## **BOARD OF VARIANCE**

(a) **APPEAL NUMBER:** B.V. 6348 **6:00 p.m.**

**CIVIC ADDRESS OF PROPERTY:** 4892 Carson Place

**APPEAL:** An appeal for the relaxation of Section 102.6(1)(a) of the Burnaby Zoning Bylaw which, if permitted, would allow for the construction of a new single family dwelling with a detached garage at 4892 Carson Place, with a principal building height of 31.99 feet (sloping roof) measured from the rear average grade, where the maximum building height of 29.50 feet is permitted. Zone R2.

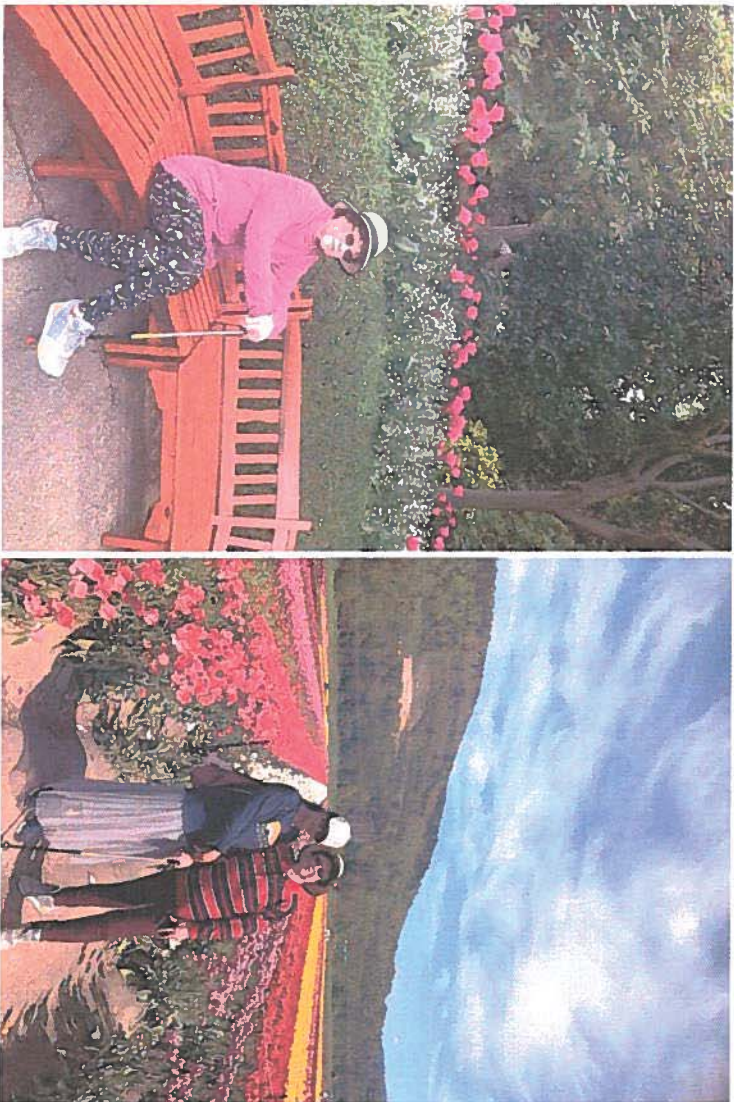
**Increase building height from 29.5' to 31.88' (increase by 2.38')**

**2. From Design perspective**

The property is located at the lower (south) side of Carson Street, in the Burnaby South Slope area. In order to reduce stairs and slopes to make the main floor accessible for the owner's mother, I try to keep the existing outside ground levels at the front. It is calculated that the lowest possible elevation of the main floor is 176.5': around the same level as ground elevation at the front property line. The main floor interior ceiling height is proposed as 10' and upper floor ceiling height is 8.5'. The slope of the roof is 4/12, which is the minimum for sloped roof defined by Burnaby Zoning Bylaw. As a result, the proposed roof pitch height works out to be 20'1" at the minimum. However, the proposed dwelling would observe a height of 25.33' when viewed from Carson Street (front) property line, which is still 4.17' lower than the Zoning Bylaw height requirement of 29.5 ft. On the technical perspective, it is unwise to build the house lower than the existing ground level or make a portion of the roof flat considering the great number of rainy days of Vancouver. New houses that built with main floor lower than outside ground level may create unnecessary drainage problems and a combination of flat and sloped roofs may leak when the house settles. Compare to the mere 2.38' height increase that we requested, it is worthwhile to keep the sloped roof and existing main floor height.

The proposed increase in building height is 2.38'. Please consider our proposal.
